From: WELLS Russell D (AREVA NP INC) [Russell.Wells@areva.com]
Sent: Thursday, December 17, 2009 6:35 PM
To: Tesfaye, Getachew
Cc: Pederson Ronda M (AREVA NP INC); BENNETT Kathy A (OFR) (AREVA NP INC); DELANO Karen V (AREVA NP INC)
Subject: Response to U.S. EPR Design Certification Application RAI No. 322, FSAR Ch 18
Attachments: RAI 322 Response US EPR DC.pdf

Response to

Request for Additional Information No. 322 (3922, 3907), Revision 1

U.S. EPR Standard Design Certification
AREVA NP Inc.
Docket No. 52-020
SRP Section: 18 - Human Factors Engineering
Application Section: 18.11
Application Section: 18.2 Operating Experience Review

Figure 18-47-1—Human Factors Engineering Design Implementation Plan

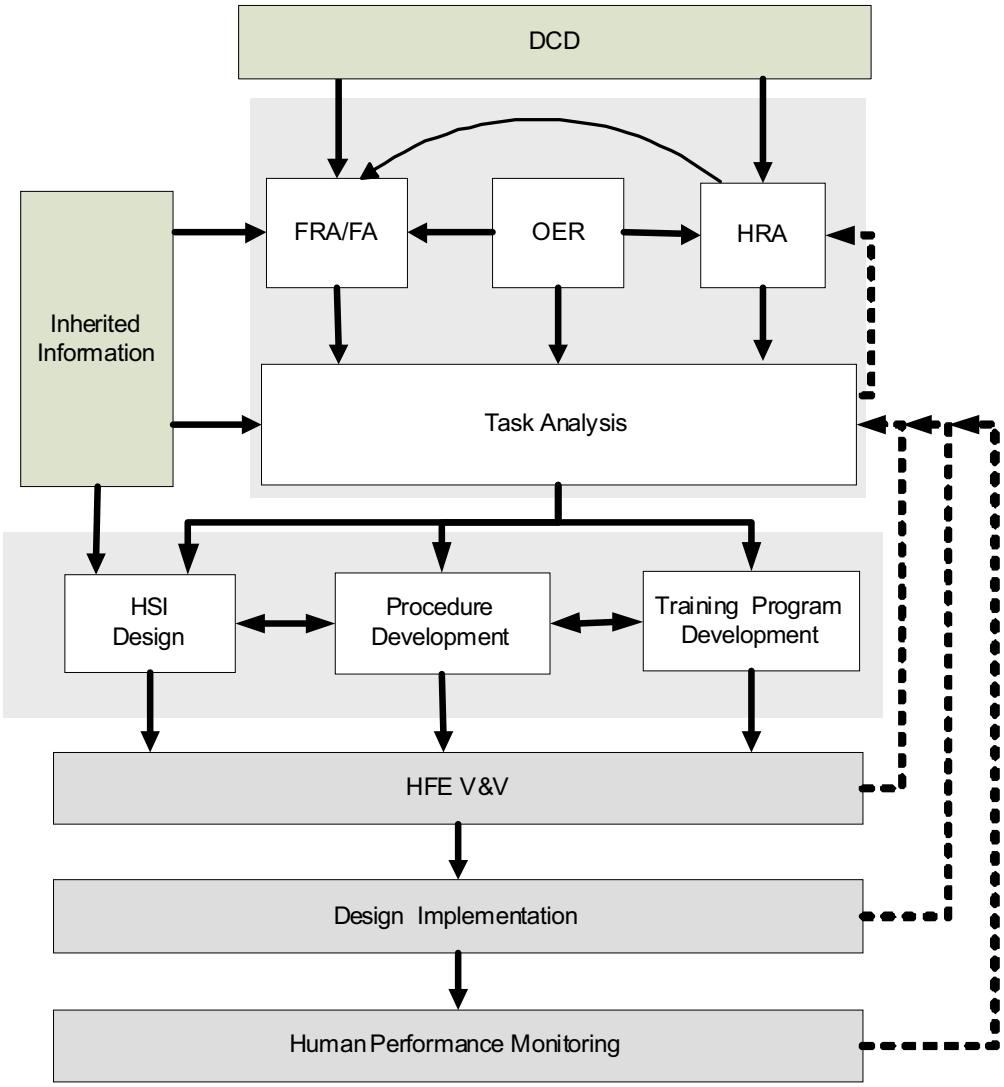
The Design Implementation Plan (document no. 118-9047891-001) Appendix A flow chart designates an HED that results from the Design Implementation process as a "Safety-Significant HED," yet in Section 3.5.1 of the Design Implementation Plan the term that is used is simply "HED." Please clarify whether the HEDs that are identified in Section 3.5.1 are the same as those in the flow chart.

Also regarding the Appendix A flow chart, it was difficult for the staff to determine the significance of the diagram and the parts within. For instance:

- Section 3.1 of the implementation plan states that the Appendix A diagram shows how the design inputs, V&V process and design implementation fit into the overall HFE design process. Where is the overall process in relation to what is shown?
- The gray boxes (that appear to be screenshots) on the left side of the diagram point to various aspects of the flow chart. It is difficult to determine if the information within the gray boxes signifies what's included in the flow diagram box it is pointing to or identifying, and whether what's described in the gray boxes are process documents, results documents, etc.
- The staff is unclear of the significance of the phases. Are the phases (Phases 1, 2, & 3) tied to both the gray boxes on the left and the flow chart?

In general, the staff requests that AREVA provide additional clarifying information giving a more detailed description of the relationship of design implementation to the EPR HFE process, and of the design implementation process itself.

The U.S. EPR Human Factors Engineering (HFE) Design Implementation Plan flowchart will be replaced with Figure 18-47-1 that is consistent with the other U.S. EPR HFE Implementation Plans and illustrates the location of the design implementation element in the overall HFE process.
